# Signaling rate range

(comment #42)

Adam Healey

October 2020 (r0)

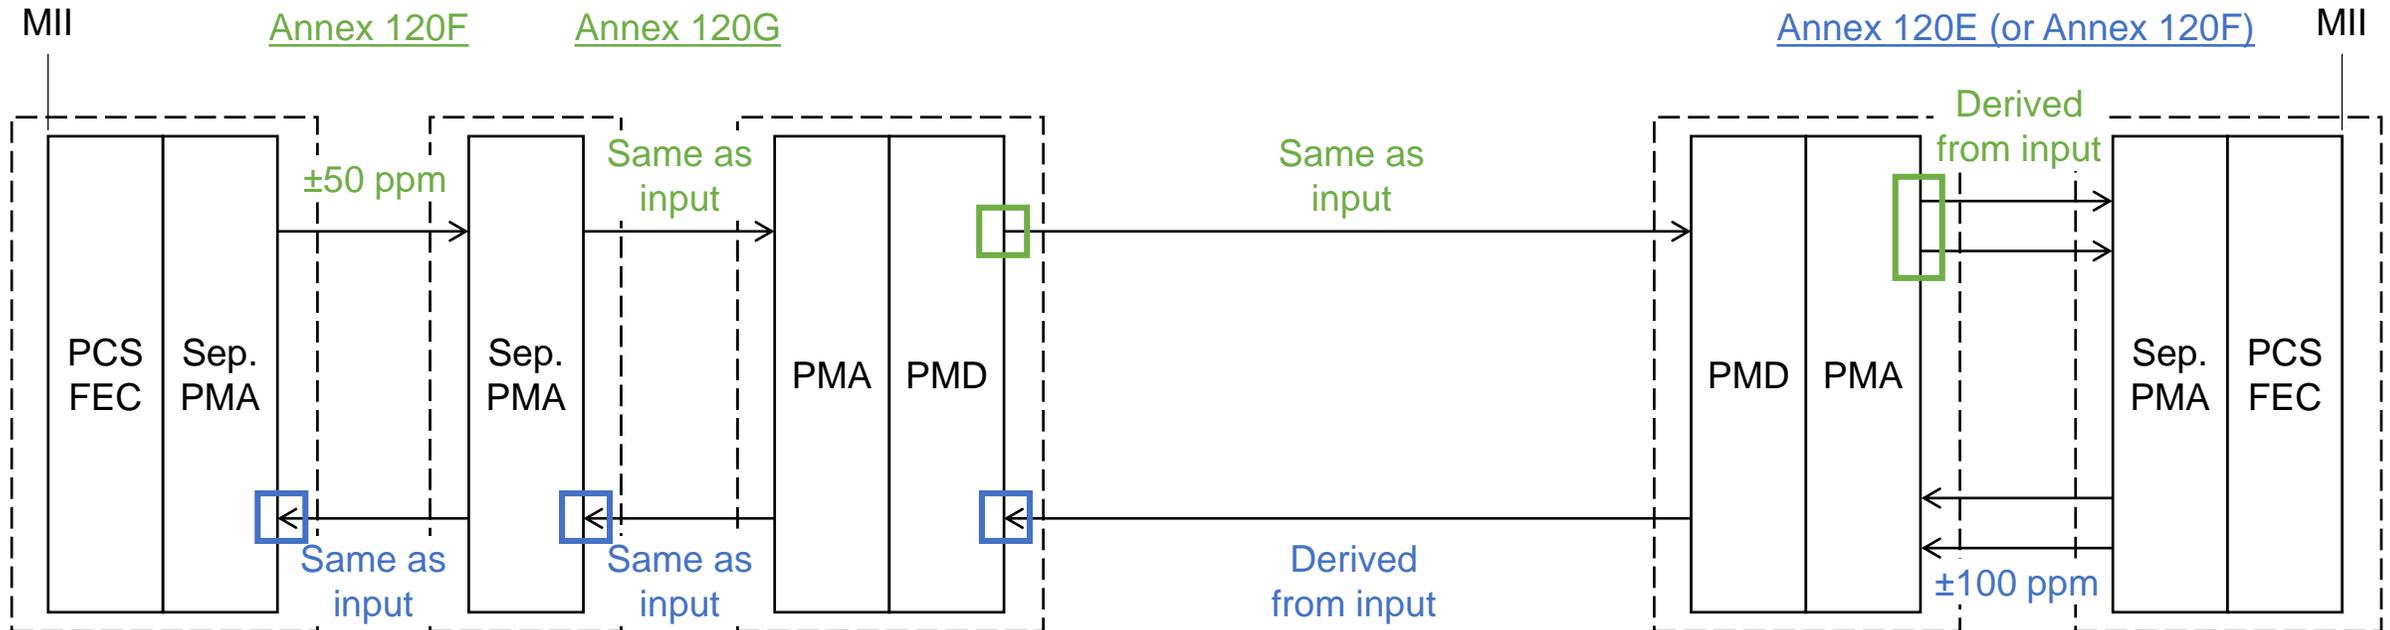
# Proposed changes to Table 120F–1 and Table 120G–1

Table 120F–1–Host output characteristics at TP0a

Parameter	Subclause reference	Value	Units
Signaling rate per lane (range)		53.125 ± <del>100</del> 50 ppm <sup>a</sup>	GBd

<sup>a</sup> For a PMA in the same package with a PCS sublayer. In other cases, the PMA signaling rate is derived from the signaling rate presented to its input lanes by the adjacent PMA or PMD sublayer.

Table 120G–1–Host output characteristics at TP1a

Parameter	Subclause reference	Value	Units
Signaling rate per lane (range)	<del>120G.3.1.1</del>	53.125 ± <del>100</del> 50 ppm <sup>a</sup>	GBd

<sup>a</sup> For a PMA in the same package with a PCS sublayer. In other cases, the PMA signaling rate is derived from the signaling rate presented to its input lanes by the adjacent PMA or PMD sublayer.

- Also, remove 120G.3.1.1 and any other references to 120G.3.1.1.
